**Catoclin Creek Scenic River Advisory Committee**  
*Protect, Preserve and Explore!*

Loudoun County Zoning Rewrite Staff, Board of Supervisors and Planning Commission  
Loudoun County, Virginia

July 10, 2022

**ZOAM-2020-0001-Zoning Ordinance Rewrite (ZOR)--  
DRAFT TEXT INPUT**  
**Prepared by Catoctin Creek Scenic River Advisory Committee**

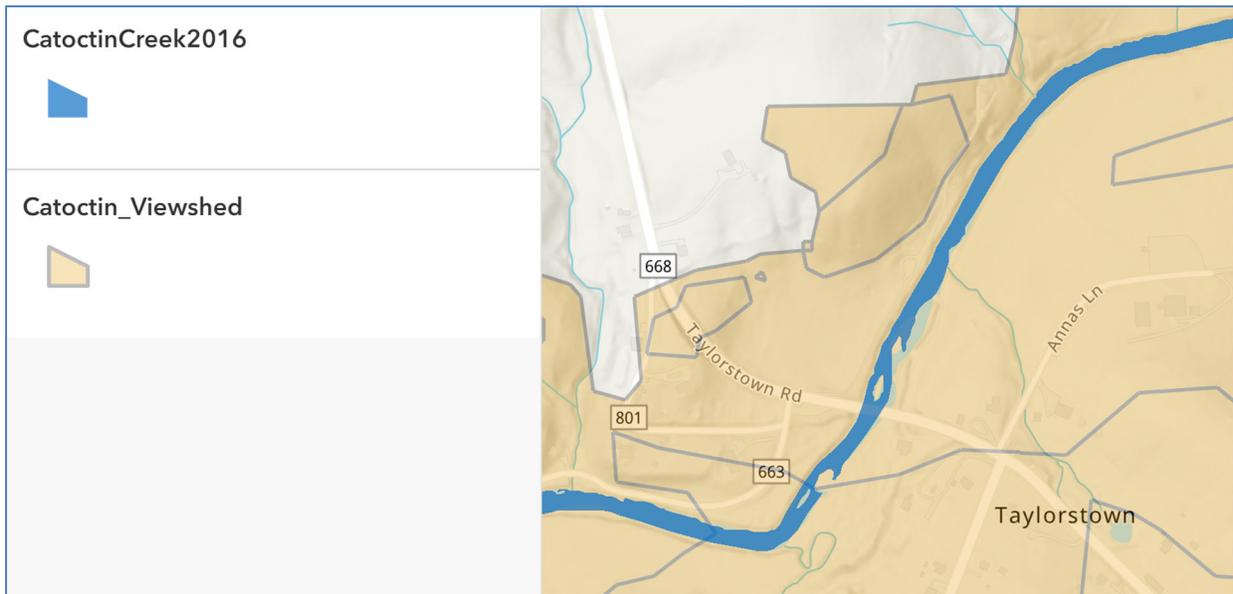
Note further that the River and Stream Corridor Resource as described in the Draft Zoning Ordinance does not include the 200-ft transition buffer which the Board of Supervisor Approved on June 1, 2021. The full width of the 500-foot buffer along the Goose Creek, Catoctin Creek, Goose Creek Reservoir, Beaverdam Reservoir, Broad Run, Bull Run and Potomac River shoreline should be revised per Board direction.

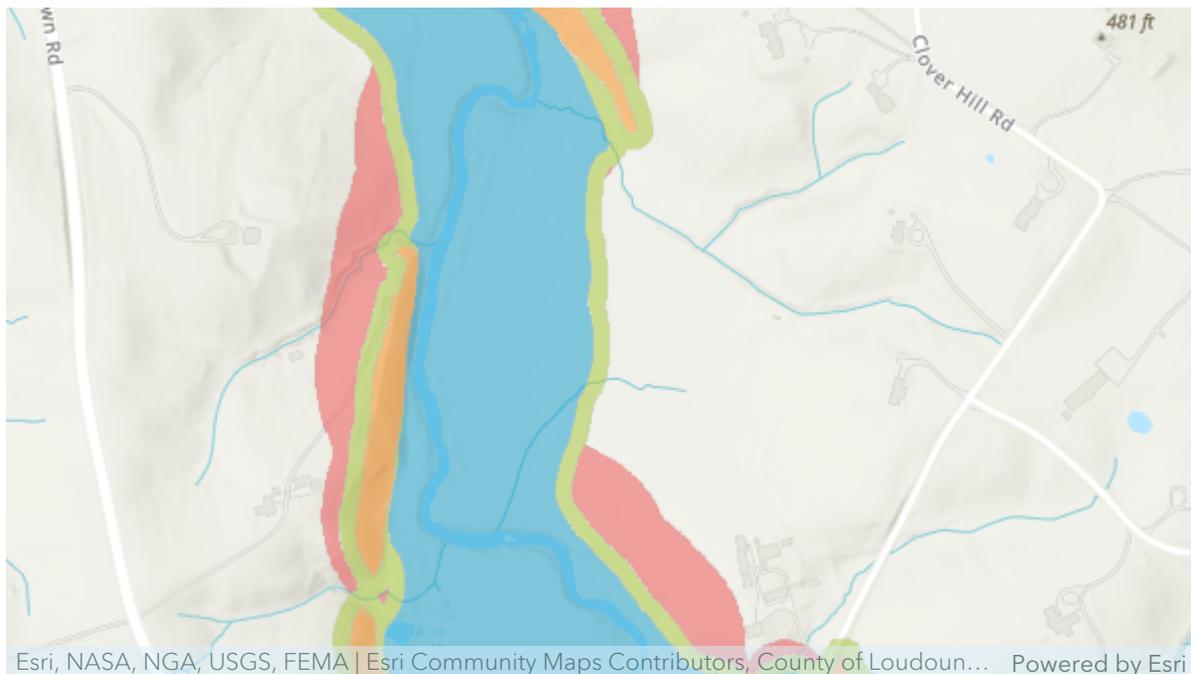
The Draft 2022 RSCR is designated using conventional definition of bankfull benches and commonly used horizontal distance measurements. and is a composite of several buffers:

- Floodplains (major and minor) for 1% change or as it is commonly referred to 100-year flood, and
- Additional Management area (50 feet), and
- Minimum 300 foot wide buffer measured from the bankfull bench along each side of Scenic Rivers, the Potomac River, and Bull Run, or
- Minimum 100 foot wide buffer measured from the bankfull bench along each side of all other rivers and streams, and
- Very Steep slopes (terrain grade is greater than 25 percent).

Note that the GIS files shown below were provided upon request to Loudoun County Office of Mapping in 2022. The data were assembled, however without bankfull bench distances. The County does not have an interactive display of the the river resources areas for public viewing, just the static map in the 2019 Comprehensive Plan.

Note further that the GIS files received do not reflect the approved 200-ft additional transitional buffer per Board of Supervisors June 1, 2021 meeting. There should be a total buffer of 500-feet along the Goose Creek, Catoctin Creek, Goose Creek Reservoir, Beaverdam Reservoir, Broad Run, Bull Run and Potomac River shoreline. In other words, the current draft does not reflect BOS approved 500-ft buffer on major waterways.
